July 2, 2021

I, Andrea Battison, as an aggrieved person respectfully request that the City of Charlottetown reconsider the approval of the site specific exemption amendment for 199 Grafton Street (207-BYL-21) which passed second reading of Council on June 14, 2021. This request is made under provisions 3.15.3.a and 3.15.3.c of Section 3.15 Reconsideration, of the Charlottetown Zoning and Development Bylaw (hereafter referred to as 'the *Bylaw*').

Figure 1. Excerpt from page 69, *The 500 Lots Standards and Guidelines*. Note the use of progressively diminishing height away from the Downtown Core (DC) area. The dashed box shows the area of proposed development. Legend indicates a maximum of five (5) storeys or 18 m (60.7 ft) for that area.

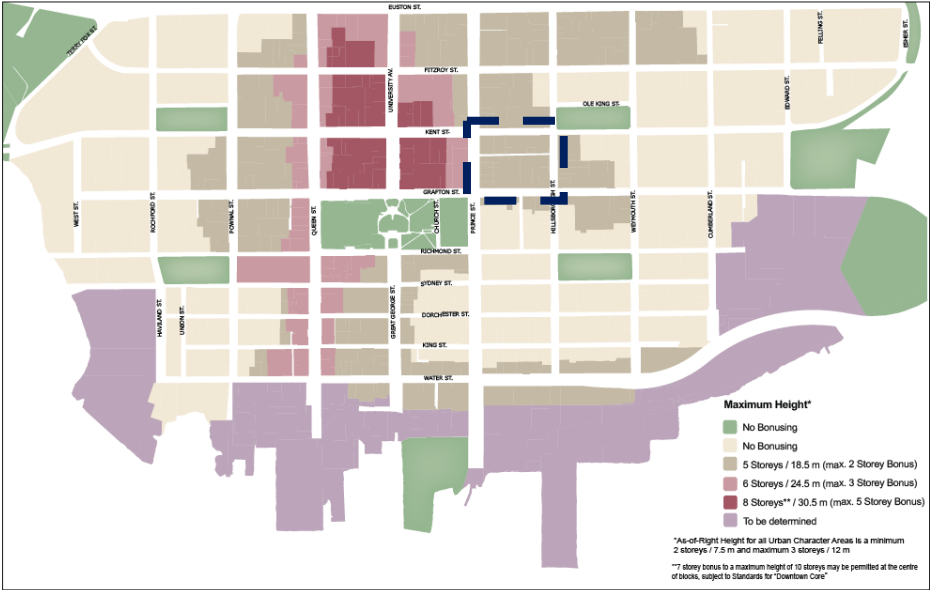
The 500 Lots Standards clearly indicate a maximum height of 60.7 ft, inclusive of bonus height, in the block containing the 199 Grafton Street proposal. This allows for the design principle of progressive diminishing of height from the Downtown Core (DC) zone into the Downtown Mixed Use Neighbourhood (DMUN) Zone.

It is argued that as the proposed building, at an average height of 70.4 ft, is higher than allowed for the zone, and higher than any other building in the immediate area, it would disrupt the progressive decrease in height from the DC to DMUN zone and so approval of the proposal would reflect poor planning principles and so is not compliant with Section 3.11.1.d of the Bylaw.

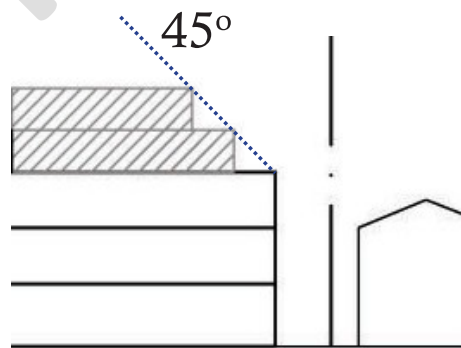
However, the property at 142-146 Prince Street represents the flank yard beside a building applying for bonus height. A definition of 'flank' does not appear in the Appendices of the Bylaw and so the general definition of a flank as a 'side' can be applied.

Given that the building at 142-146 Prince Street is residential and that the entire block is zone DMUN, and that Sections 30.3.2.a and 30.3.2.b have been applied to calculate the frontage and step back variance requests for the proposed building, section 30.3.2.c.ii and 30.3.2.c.iii should also apply:

It is argued that the side (flank) yard abutting 142 -146 Prince Street requires step backs of 10' 11" at the fourth and fifth storeys. These variances descriptions were not included in the request for a site specific amendment or the resolution and therefore the ~~request~~ both are is incomplete. This reflects poor planning principles and is not compliant with Section 3.11.1.d of the Bylaw.
